State of Vermont Department of Health

Radioactive Materials Program

Procedure 2.5, Revision 0

Enforcement, Escalated Enforcement, and Administrative Actions

Enforcement Process

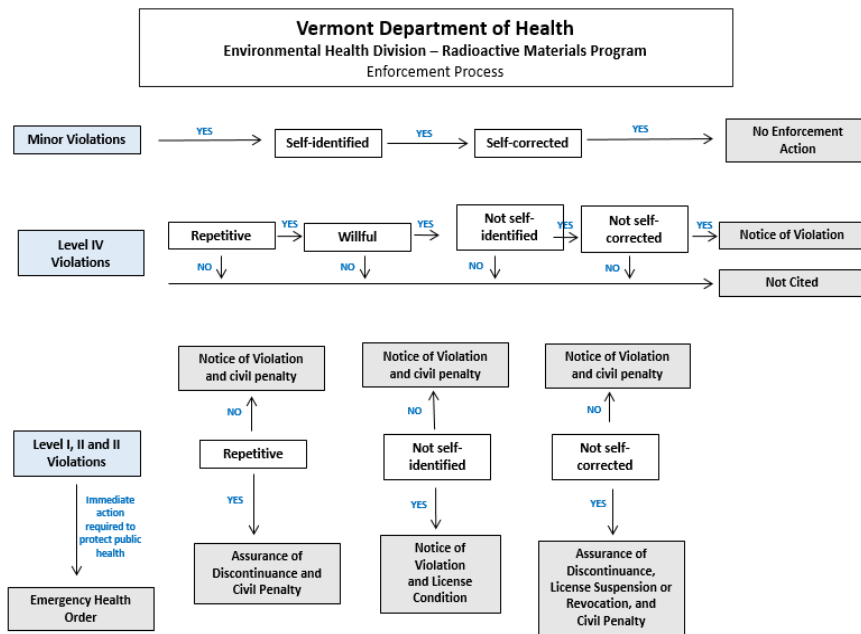
Commented [SJ40]: This chart should be revised as follows:

- The “not self-identified” boxes are confusing because of the double negative. Suggest that VT make all those boxes “self-identified” like the minor violations flow chart path.
- Suggest revising the “not self-corrected” boxes to “self-corrected” for the same reasons—i.e., the double negative is confusing.
- There is a typo in the “Level, I, II, and III Violations” box—II is listed twice.
- To model the NRC’s enforcement program, willfulness (i.e., careless disregard OR deliberateness) should play a role in the SL I-III violations. The NRC may escalate if willfulness is involved – e.g., a willful SL IV can become an SL III.

Commented [SM42R41]: OK
